AGENDA

MATANUSKA-SUSITNA BOROUGH

PLATTING BOARD MEETING

March 6, 2025

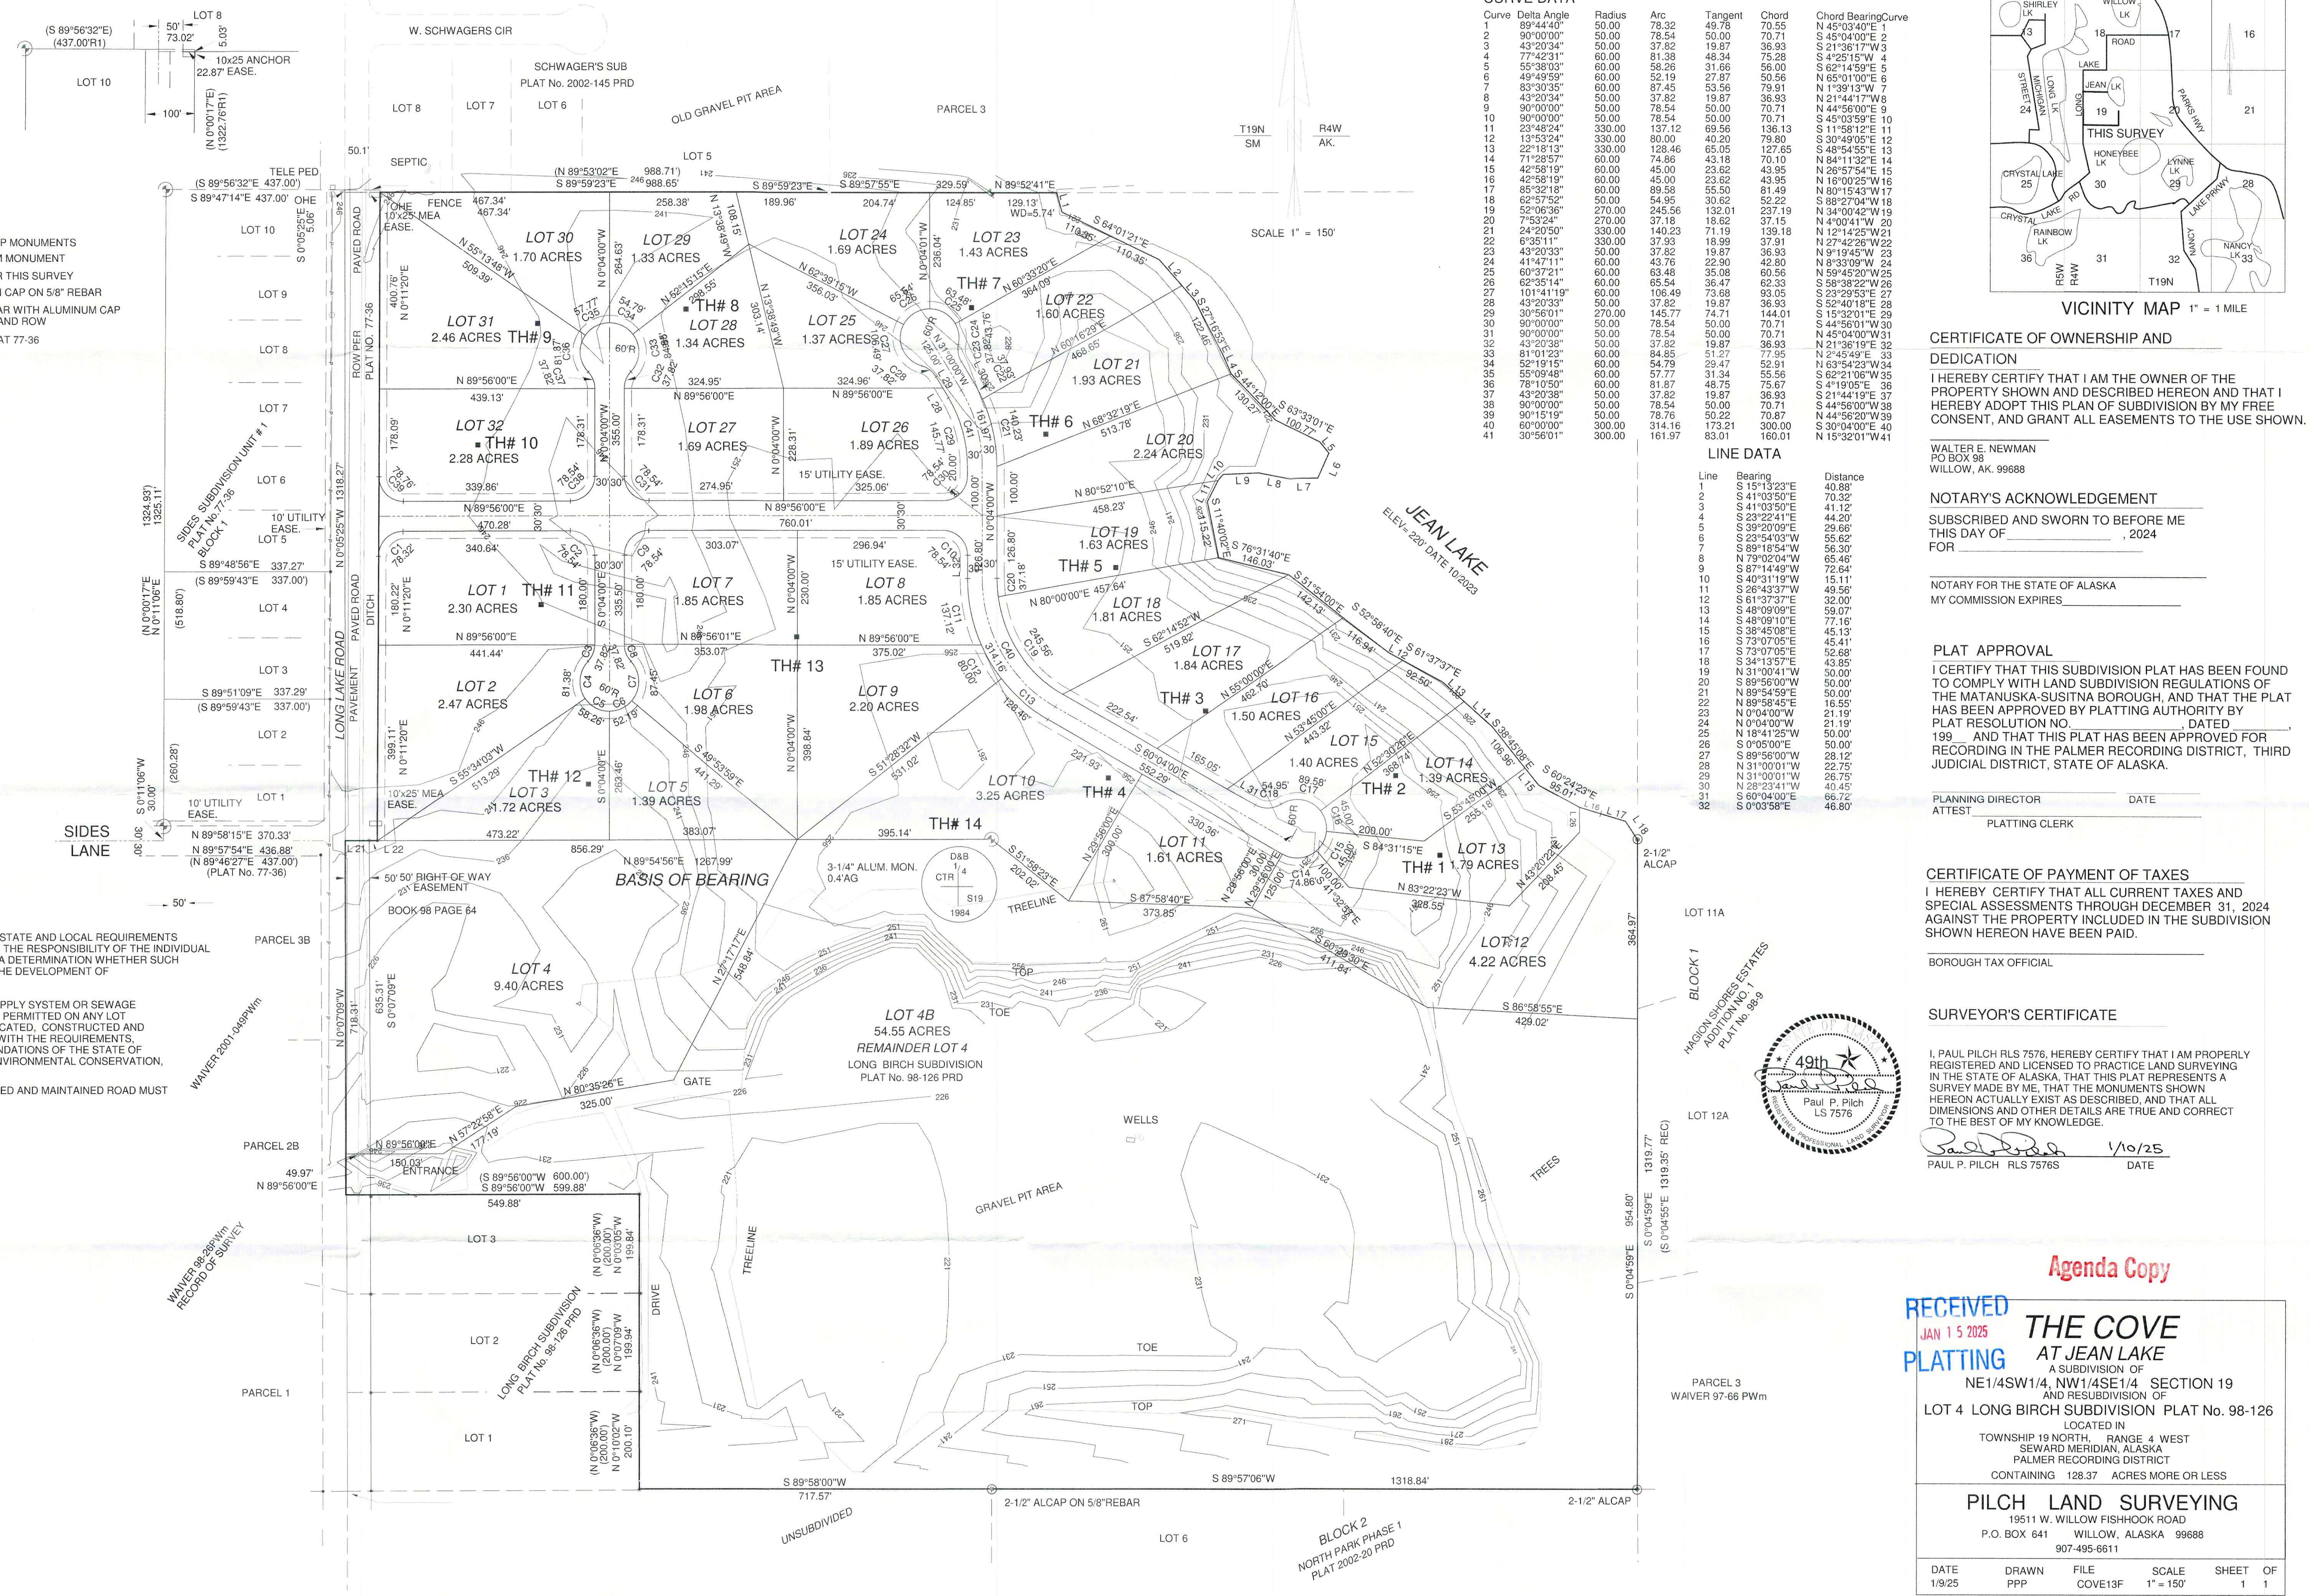
- Recommend secondary subdivision emergency access connectivity through Lot 4B with subsequent development of Lot 4B. Recommend southeastern subdivision road connect to Lot 4B near lots 11 and 12 to provide future connectivity.

- DOT&PF will permit two access points to Long Lake Road – one for subdivision and one for Lot 4 and 4B, please plan accordingly.
- Add plat note: “No direct access to Long Lake Road for Lot 30, 31, 32, 1, 2, 3, and 4.”

MSB DPW Pre-design and Engineering (**Exhibit D**) The ADT estimate looks acceptable. The comments I sent earlier today regarding drainage stand: According to SCM D02.1, show the ordinary high water mark on the drainage plan with a 100' upland offset. Provide a more detailed drainage plan showing proposed cross culverts, drainage arrows on all lots, and proposed drainage basins. Show proposed drainage easements on the plat. A large portion of runoff from the site appears to drain onto the north west corner of Lot 4 and then be detained in the natural basin. Show proposed drainage easement on Lot 4 for where the water is expected to be detained and provide a drainage path outlined in the drainage plan for the runoff to reach here.

- e) Submit as-built of streets and drainage improvements to Platting staff once construction is complete.
5. Add plat note: "No direct access to Long Lake Road for Lot 30, 31, 32, 1, 2, 3, and 4."

6. Dedicate a common access easement for lots 4 and 4B.
7. Pay postage and advertising fees.
8. Show all easements of record on final plat.
9. Submit recording fees, payable to Department of Natural Resources (DNR).
